ERRATA SHEET # 150320

XBee Development Kits

This errata sheet documents a resolution for a known issue with the USB port use on XBee® development board kits shipped prior to 2/23/15.

Image 1:

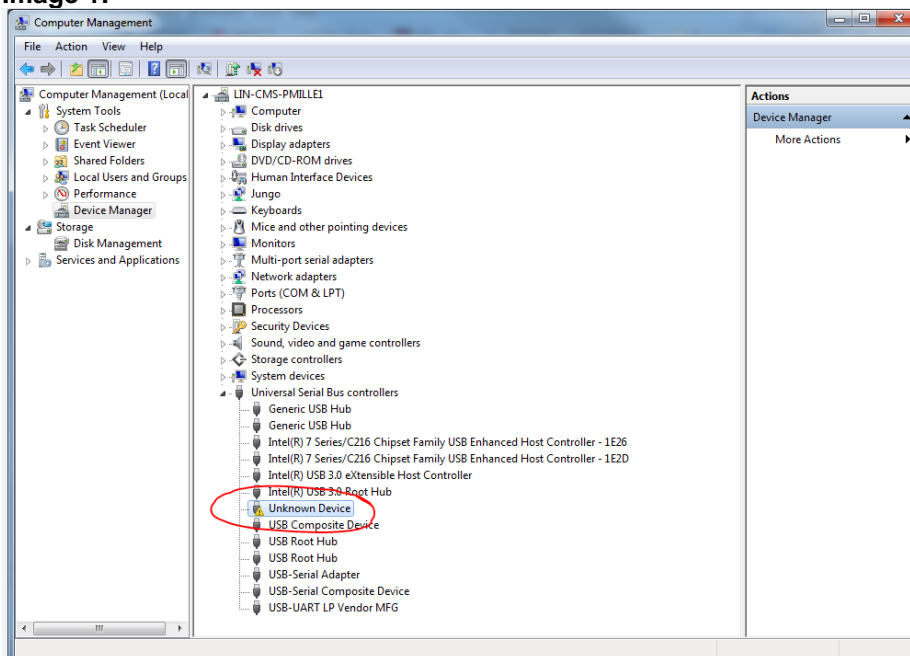
- 1) Plug in the USB port to your PC
- 2) Open up "Device Manager" from your windows PC to make sure all USB units do not have errors. A faulty connection will show up as a USB icon with an exclamation mark. Below in image 1 is a screen shot highlighting a faulty USB connection

To resolve the issue, the barrel jack must be supplied with between 6v to 20v of power, prior to connecting the USB port. If the barrel jack is supplied with between 6v to 20v prior to the USB connection, the board will always function properly. However, the barrel jack must be connected first, followed by the USB to guarantee correct operation.
